**Re: Request advice on the Amendment Report for SSD-58978472 – Kelso Crescent
Multi-Level Warehouse, Moorebank**

Attachment A – Detailed Comments

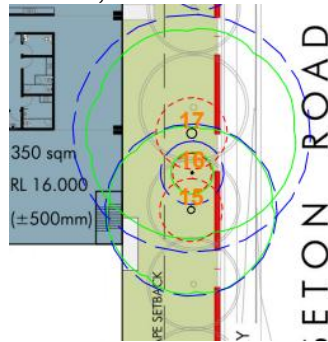
Tree Retention
 Several native, mature trees in good condition and within the front landscape setback and proposed to be removed (being: T15, T16, T17, T36 and T37), and this is not supported. Pot sizes should therefore be increased for several of the trees to a minimum 100L, and 200L for street trees, to reduce the time it will take for canopy to establish

These trees are all native, mature trees, all in at minimum good condition except for T16 which is 'fair' condition. T36 – the pedestrian entry could be reconfigured to keep.

Unclear why T15, T17 cannot be retained as well, now that T16 is being retained.

The Arborist report just states 'Remove' against these trees with no justification why.

Street trees have not been shown, these should be shown and pot sizes at 200L.

Not Addressed. Refer to Recommendation above this table.

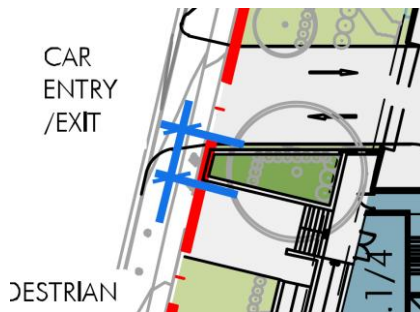
The Kelso Crescent car park entry is very close to the main pedestrian entry. Council recommends the applicant increases the separation between both entries to improve safety for pedestrians. Council is supportive of the external terrace to the office space, however, seeks clarity as to whether it is accessible to all staff or just those working in the adjacent office. The applicant should demonstrate that all staff frequenting this development have access to good quality communal space

The car park and entries are not separated by 8m landscaped as described.

The distance/dimension in question is illustrated below and appears to be 2-3m.

Not addressed. While the pedestrian entry is not far from the driveway, it runs straight through the car park. This is not a safe or appropriate way to enter a main entry of a building, through a car park. **The main entry foot path should be reconfigured to enable a direct connection to the main entry, with enough separation from the driveways and not having to walk through a car park and conflict with vehicles.**
